Groundwater Application Review Summary Form

Application # G- 18858

To: Kristopher Byrd, Well Construction and Compliance Section Manager
From: Joel Jeffery, Well Construction Program Coordinator
Subject: Review of Water Right Application G-18858
Date: October 10, 2019

TO: Water Rights Section Date 10/01/2019
 FROM: Groundwater Section Travis Brown
 Reviewer's Name
 SUBJECT: Application G- 18858 Supersedes review of _____
 Date of Review(s)

Well Location Map

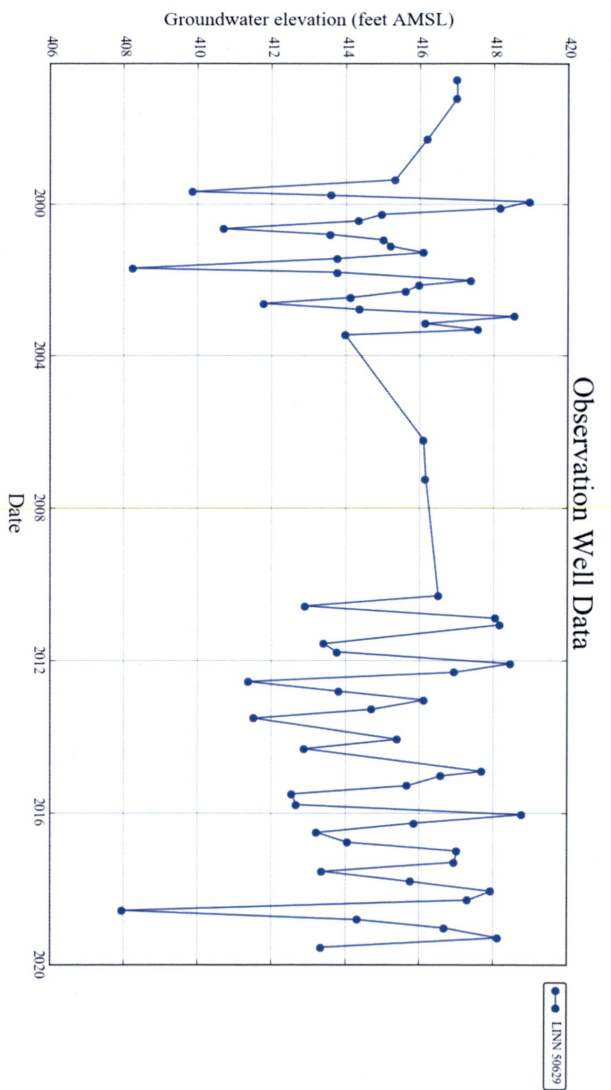
A4. **Comments:** The proposed POA/POU are located ~1 mile south of the City of Turner, Oregon. The proposed total annual volume of use is 480 af/year. **NOTE: Based on the acreage of the proposed POU [95.9 acres] and the containerized plant Nursery Use duty of 5 ft, the maximum allowable use should be 479.5 af/year.**

The sum of the reported well yields (~765 gpm or ~1.705 cfs) for the proposed POA is ~0.685 cfs less than the requested rate (2.39 cfs). It is unclear how the applicant plans to achieve the requested rate using only the proposed POA.

The nearest-known neighboring groundwater user to the proposed POA is MARI 60103, a domestic well registered to Dave Lawton. The exact location of MARI 60103 is not known, only that the well is within the bounds of Marion County tax lot 1200. As a domestic well, it is assumed that MARI 60103 is in close proximity to the buildings at the south end of tax lot 1200. The assumed location of MARI 60103 is ~900 ft northwest of proposed POA 2 (MARI 52488). Based on the unconfined nature of the aquifer and the distance between the proposed POA and MARI 60103, the proposed use is not anticipated to prevent MARI 60103 or similarly-located groundwater users from appropriating water to which they are legally entitled.
